# UNITED STATES PATENT AND TRADEMARK OFFICE

APPLICATION NO.	FILING DATE	FIRST NAMED INVENTOR	ATTORNEY DOCKET NO.	CONFIRMATION NO.
10/523,926	02/07/2005	Jan van Walraven	WALRAVEN3	1885
1444	7590	12/01/2006	EXAMINER	
BROWDY AND NEIMARK, P.L.L.C. 624 NINTH STREET, NW SUITE 300 WASHINGTON, DC 20001-5303			DUMAS, NKEISHA J	
			ART UNIT	PAPER NUMBER
			3632

1. The following correspondence is a non-final Office Action for application number 10/523,926, for a VIBRATION ISOLATING PIPE CLIP, filed on 2/7/2005. Claims 1-20 have been cancelled. Claims 21-43 are pending. Claim 43 is withdrawn pursuant to a restriction requirement.

**Fig. 2**

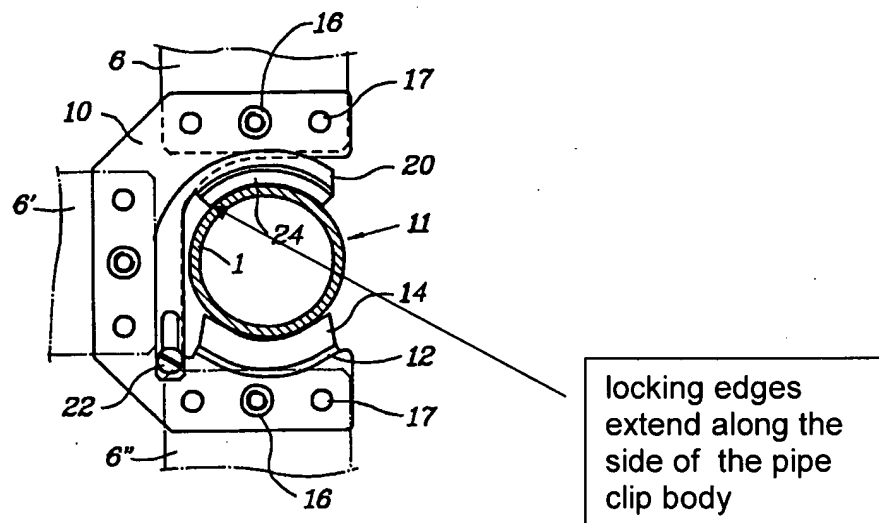
Regarding claims 37 and 38, Gerster and van Walraven teach the pipe clip of claim 36, and, as best understood Gerster teaches that the vibration isolating member is provided with retaining edges that extend along the side edges of the pipe clip body and interact with the pipe clip body in a positively locking manner (Fig. 2) (see below).
